CPRE Shropshire

15 November 2019

Welsh Government National Development Framework Consultation extended to 15th November 2019

Arup's Priority areas for Solar and Wind Energy and TAN8 SSAs

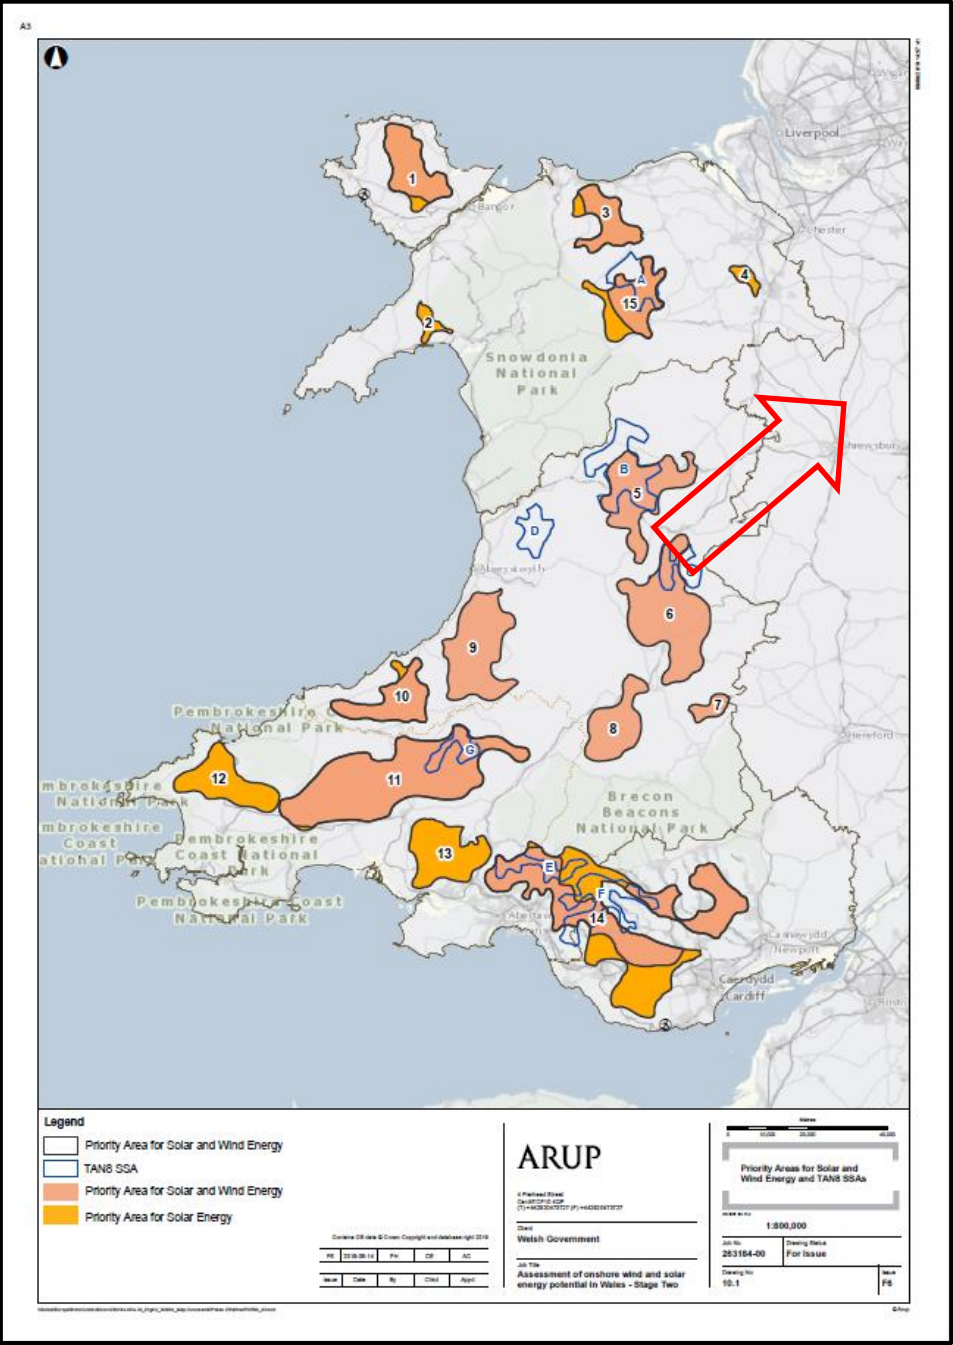
23. However, there is a huge discrepancy in the areas now put forward as EPAs and the areas put forward as SSAs at the time of TAN8, as shown by Arup themselves in their map, which is reproduced in the Appendix to this response.

35. The problem that this poses is pointed up in the Appendix. This problem is that the EPAs as proposed in mid-Wales are about as far from the national electricity grid as anywhere in the UK. The red arrow indicates the direction, well into England, of the connection proposed by the National Grid Mid Wales Connection Project.
